Preapplication Safety Evaluation Report for the Sodium Advanced Fast Reactor (SAFR) Liquid-Metal Reactor

U.S. Nuclear Regulatory Commission

Manuscript Completed: September 1991
Date Published: December 1991

This safety evaluation report (SER) presents the results of a preapplication design review for the standard modular Sodium Advanced Fast Reactor (SAFR) liquid metal reactor (LMR), NRC Project No. 673. The SAFR conceptual design was submitted by the U.S. Department of Energy (DOE) in accordance with the U.S. Nuclear Regulatory Commission's (NRC) "Statement of Policy for the Regulation of Advanced Nuclear Power Plants" (51 Federal Register 24643). This policy provides for early Commission review and interaction with designers and licensees. The standard SAFR design consists of four identical reactor modules, referred to as "power paks," each with a thermal output rating of 900 MWt, coupled with four steam turbine-generator sets. The total electric output is 1400 MWe. The reactors are liquid sodium cooled and use metallic-type fuel, a ternary alloy of U-Pu-Zr. The design includes passive reactor shutdown and decay heat removal features.

Figure 15.1 SAFR adiabatic heatup core outlet sodium temperature.

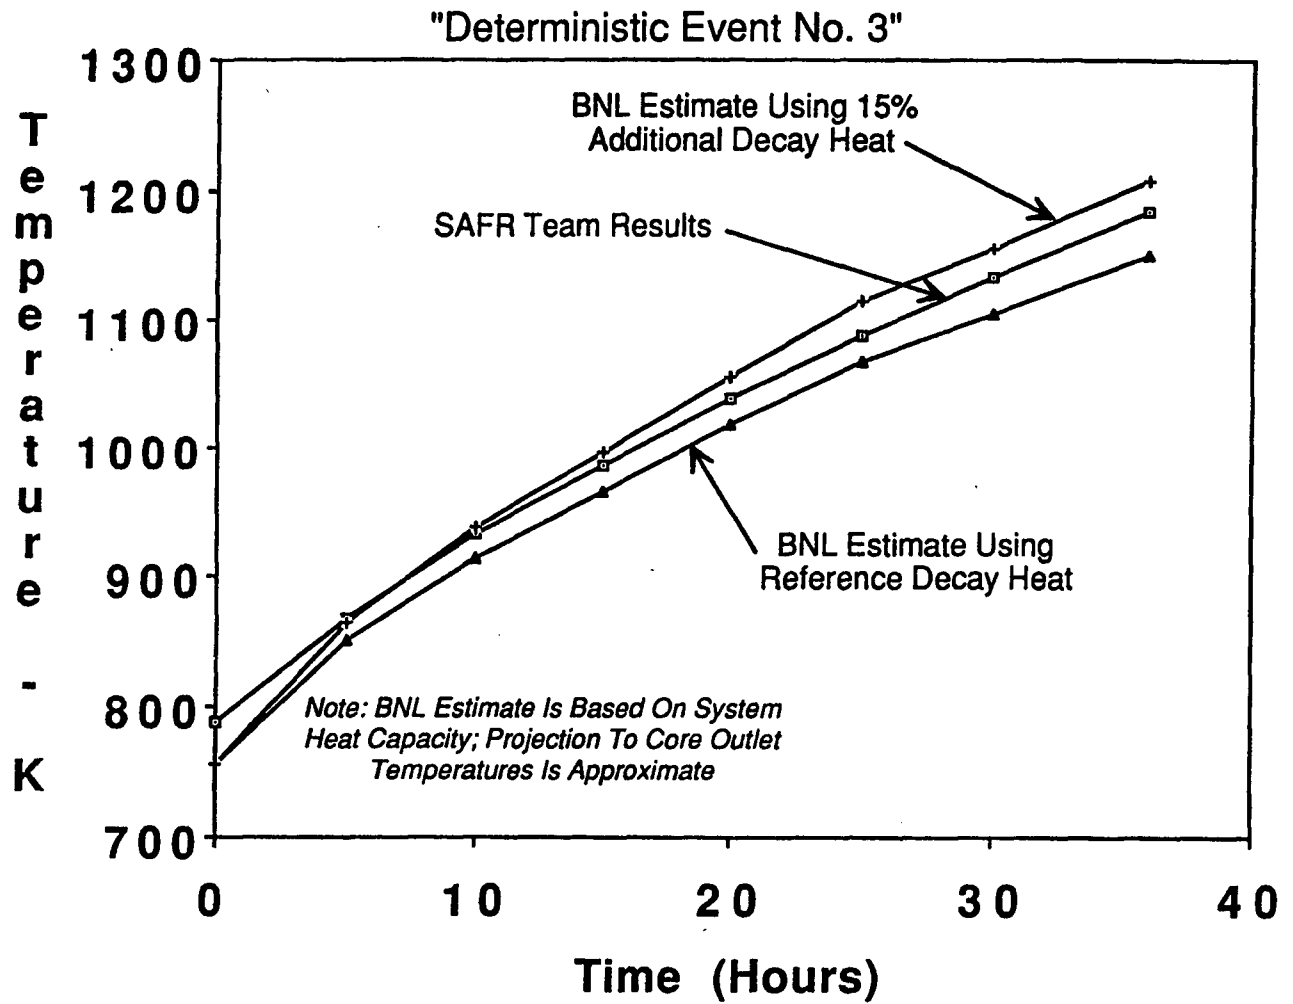
An independent calculation using simple heat capacity analysis confirms the SAFR projection of temperatures as shown in Figure 15.1. It also is apparent from eutectic failure versus time charts that large-scale failures would develop around 24 hours into the event. Thus, the RI projection of system temperatures and reactor damage are assumed to be correct. However, assumptions regarding fission-product retention in sodium pools are based in part on data from oxide fuel, and metal fuel would behave somewhat differently. Thus, RI's projection of low doses at the site boundary may be difficult to confirm in the near term. Further, large-scale failures in an LMR core would result in the movement of fuel, which could lead to subsequent recriticalities. The outcome of this event, were it to occur, could be far more severe than is indicated by RI's dose estimates.

Figure 15.2 Schematic representation of LMR used in MINET pipe-break analysis.

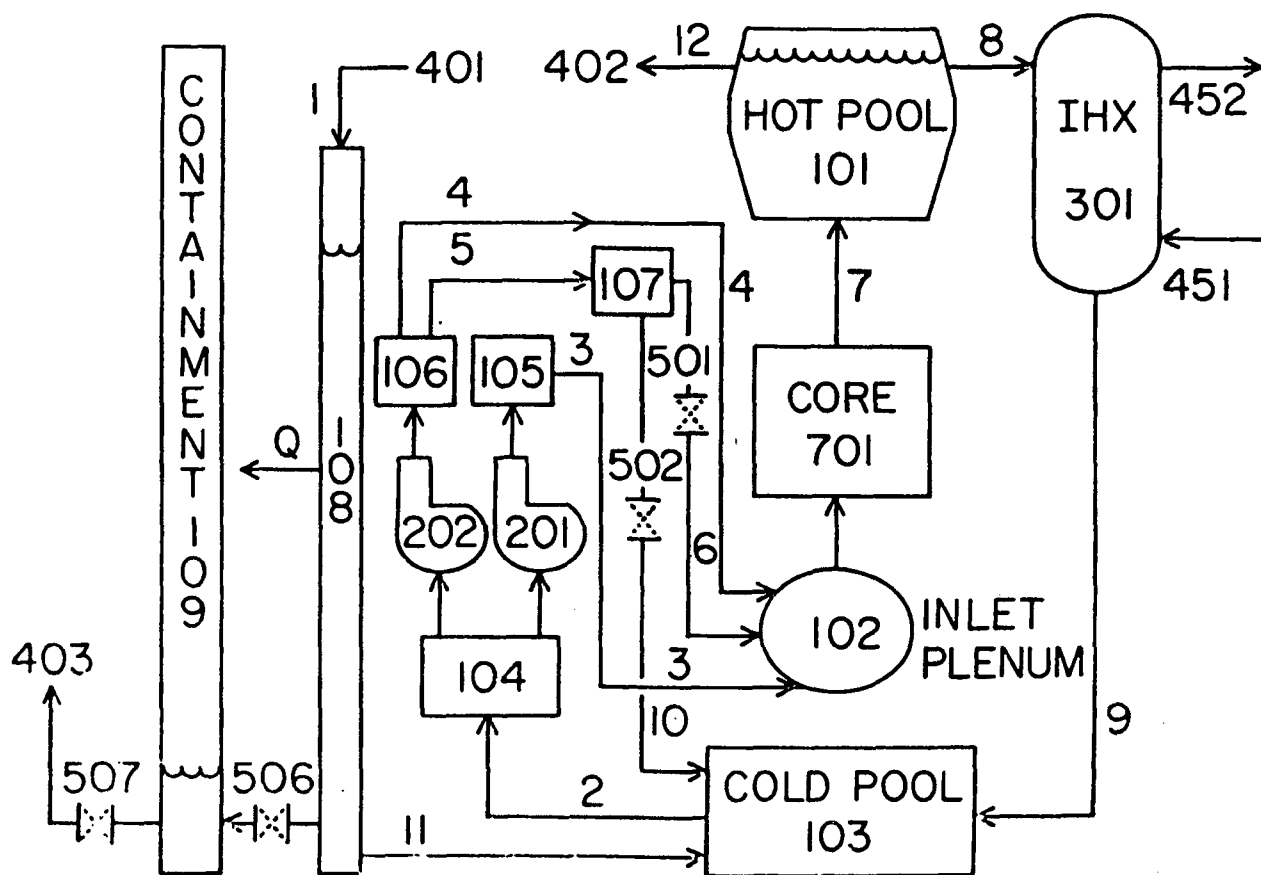
In the independent staff analysis, the MINET code (Ref. 15.9) was used to model the flow network around the core, as indicated in Figure 15.2. The most important aspect of this analysis is the modeling associated with the behavior of the (1) operating and (2) seized pumps. This ultimately determines how much flow will continue through the core. The seizure causes a drop in system impedance, while the unfailed pump experiences a large flow increase to 128 percent of its rated condition, causing the pump to cavitate. (The designers are fully aware of this problem and believe that they can design a pump to operate in this regime.) The resistance through the locked rotor directly determines the amount of flow that will bypass the core and feed back into the cold pool. The MINET model accounted for all of the above effects and found that 65 percent of the system flow will bypass the core through the locked rotor. As shown in Figure 15.3, the remaining 35 percent of the system sodium flow will still continue to flow through the core.

Figure 15.4 SUPERSYSTEM code representation of liquid-metal reactor systems.

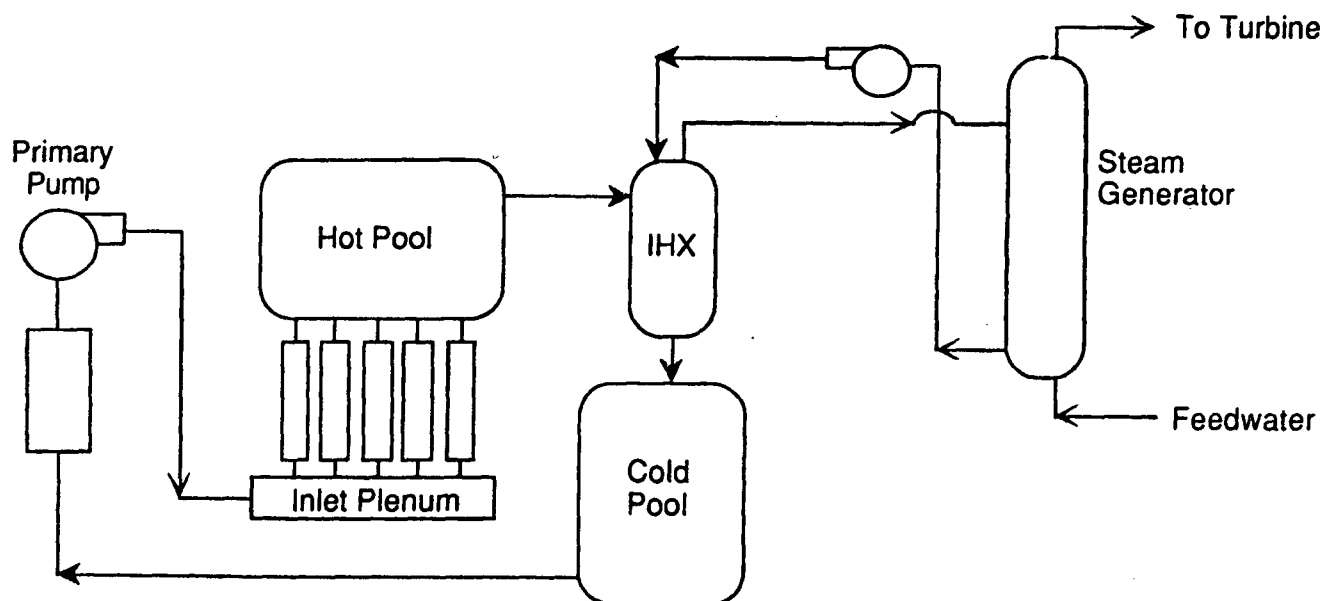
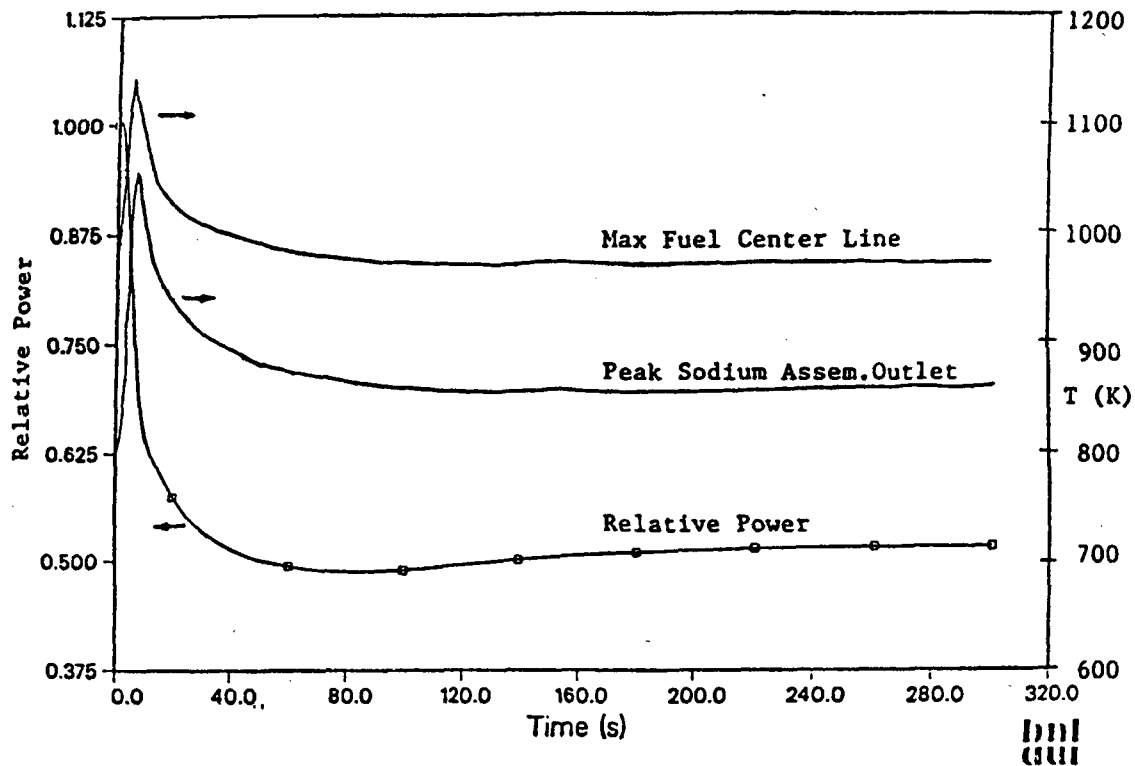
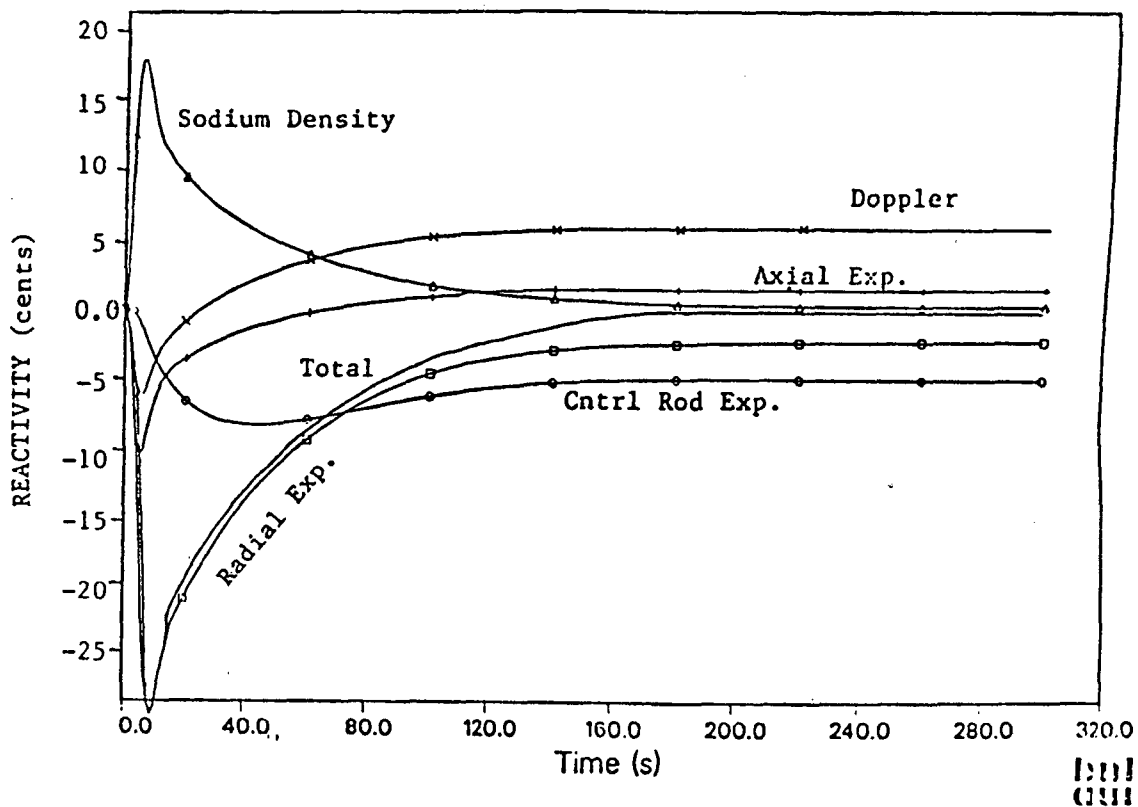
The prescribed flow condition from MINET was simulated in the SUPERSYSTEM code (see Figure 15.4), and the results from that simulation are presented in Figures 15.5 and 15.6. The power in Figure 15.5 drops immediately to 50 percent and reestablishes a critical condition at about 52 percent of rated power. In Figure 15.6, the reactivity feedbacks that make up the passive response to a sudden loss of flow in a metal-fueled core are shown. The initial reduction comes from the Doppler and axial expansion feedback. This generates a negative feedback, as both give a negative feedback for a temperature increase. Within the first few seconds, Doppler and axial expansion insert -6% and -9% , respectively. The drop in sodium flow, coupled with the increase in fuel temperature, leads to increased sodium temperature, which generates a positive feedback. This added about $+17.5\%$ of reactivity at its peak, and then slowly returned to zero at around 200 seconds when the reactor reestablished criticality. Hotter sodium temperatures increase temperatures in the surrounding structures and the load pads, which activates the radial expansion. From Figure 15.6, it is clear that the radial expansion feedback is the dominant mitigating factor, and that this is the most significant feedback in terminating the event.

It should be noted that the Doppler reactivity ultimately inserts only about $+7\%$ of reactivity after the power is reestablished at 52 seconds, as shown in Figure 15.6. A negligible Doppler feedback, and the correspondingly reduced temperature defect, make it possible for the small reactivities generated in the metal-fuel core to force the power to a much lower level.

Figure 15.7 Minimum margin to sodium boiling for SAFR beyond-design-basis events (BDBEs).

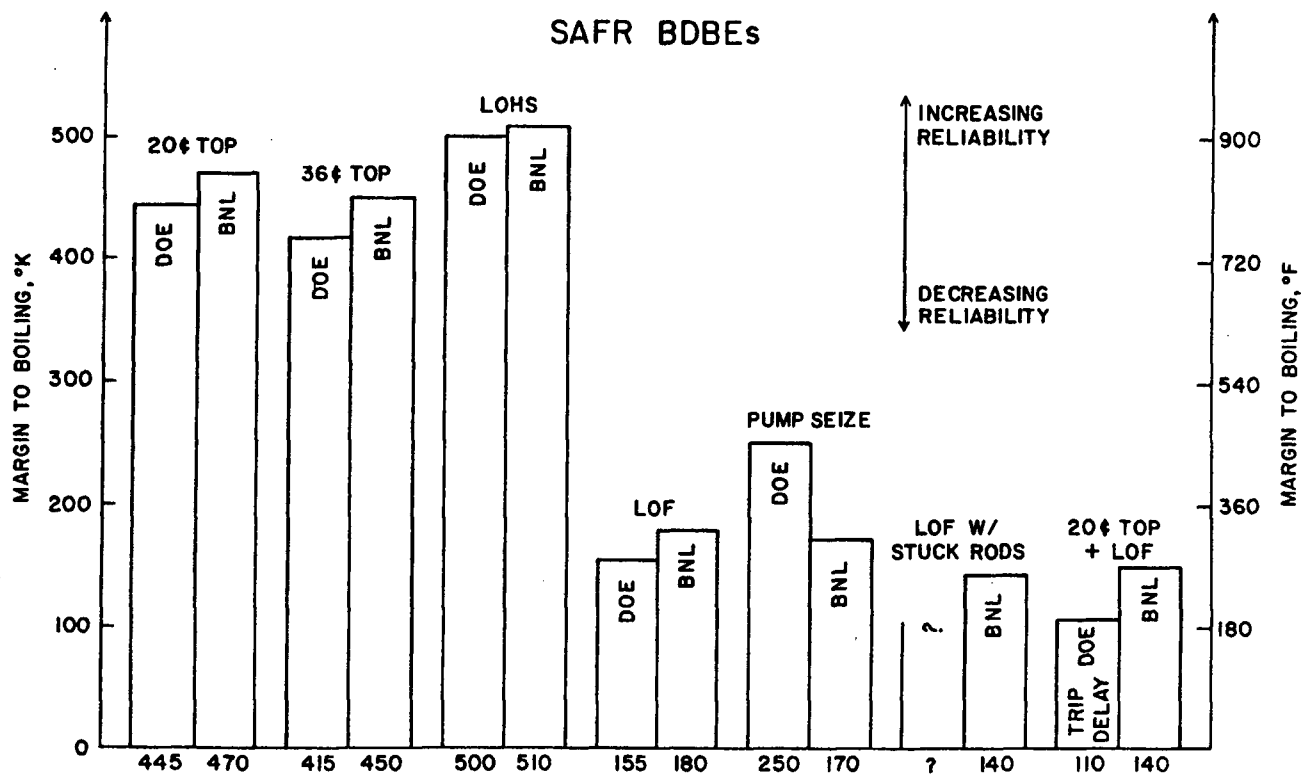
operator action, as long as the second pump continued to operate. The minimum margin to sodium boiling for seven postulated unscrammed SAFR events, as estimated by RI and ANL, and by BNL, are compared in Figure 15.7. Because the loss-of-flow events develop quickly (the power must drop quickly to avoid overheating) and because the loss of pumping reduces system pressures, the margins are smallest for those cases. However, as long as the second pump continues to run, the margin to sodium boiling is no less than for the more likely unscrammed loss-of-flow (LOF) case.

Figure A.1 SUPERSYSTEM code prediction for SAFR ULOF: Power and core flow.

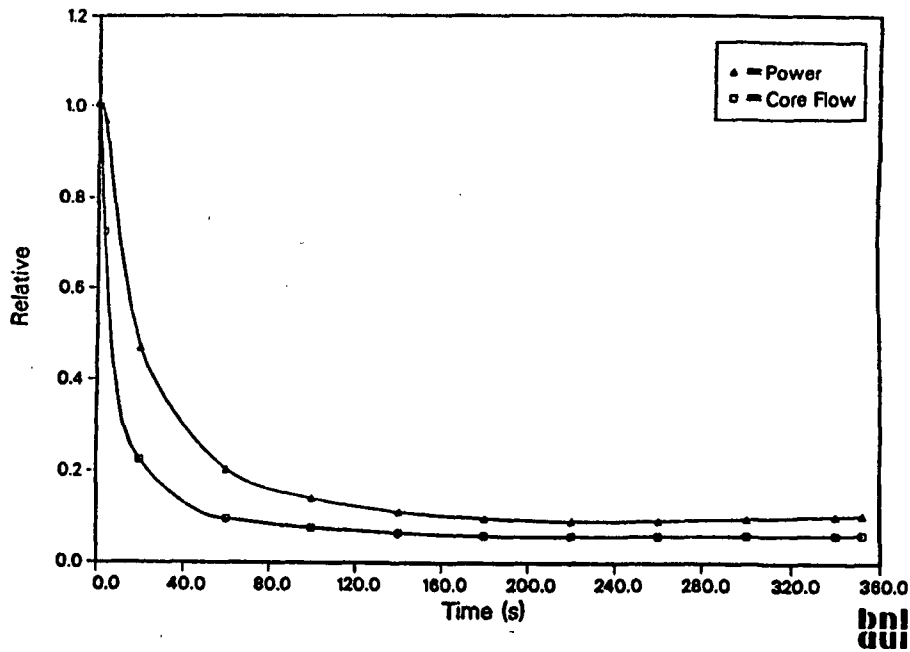
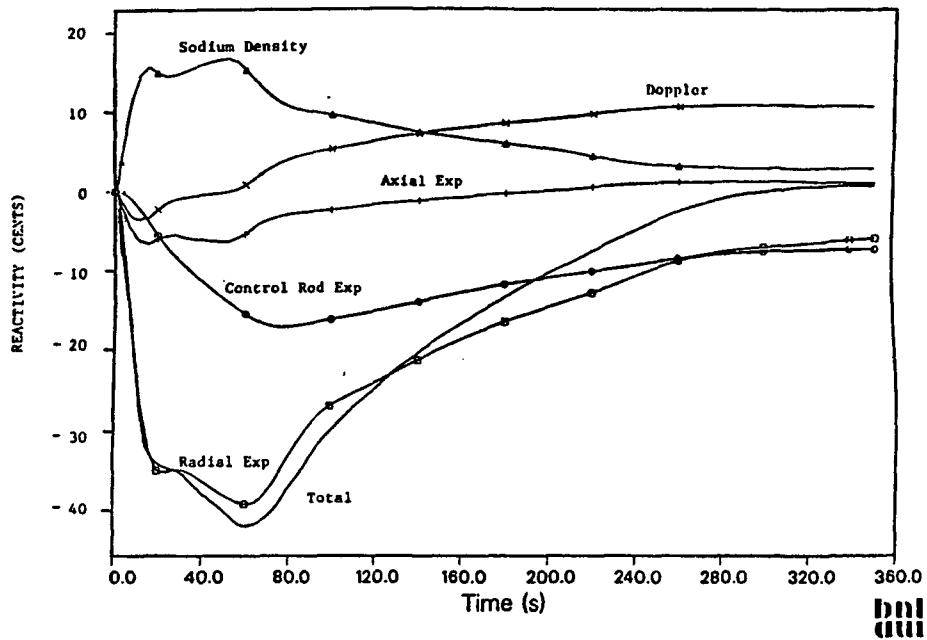
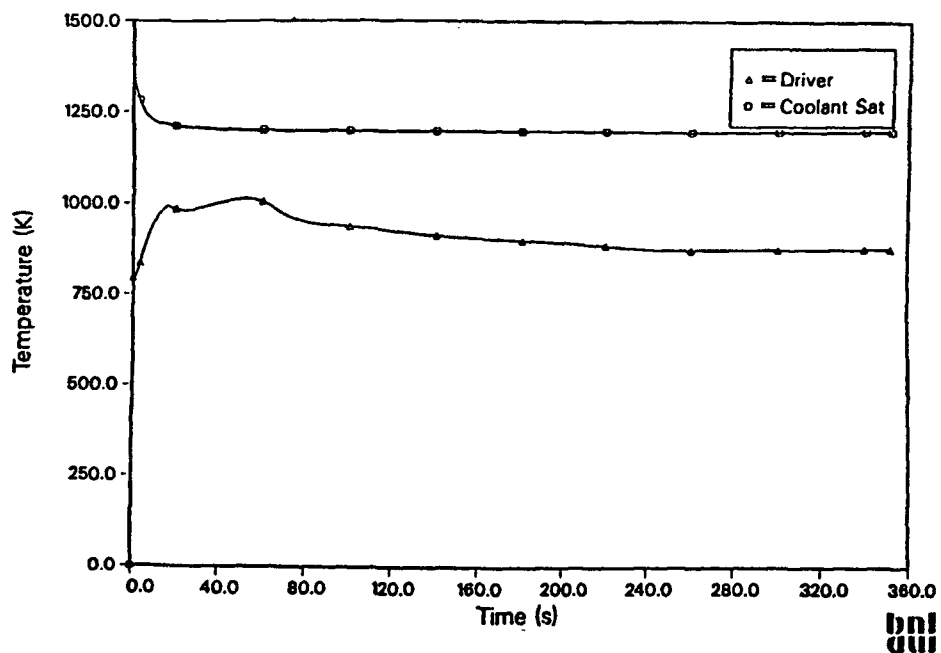
Key results are presented in Figures A.1 through A.3. In Figure A.1, it is shown that the power level drops off as the flow decreases. The fuel temperatures increase because of the reduced coolant flow in the core, activating the Doppler and axial expansion feedbacks. The reduction of coolant flow

in the core also causes the sodium temperatures to increase. This inserts positive reactivity because of the hardening of the neutron spectrum. Once the sodium begins to heat up, it disperses the heat throughout the system and activates the radial dilation at the above-core load pads, which in turn activates the radial expansion feedback. In Figure A.2, the radial expansion feedback is shown to be dominant, causing a reduction in power. By 140 seconds, the power level reaches a quasi-static level at about 10 percent of rated power, where the reactivity feedbacks are balanced and the power remains steady. The peak channel sodium exit temperature is shown in Figure A.3 to be 1020 K (1377°F) and has a 180 K (324°F) margin to boiling. The peak fuel center line temperature is 1050 K (1431°F), which gives a margin of 316K (569°F) to the fuel melting point. The reduction in the solidus or fuel-melting temperature is not considered here since the effect of the zirconium migration was not simulated.
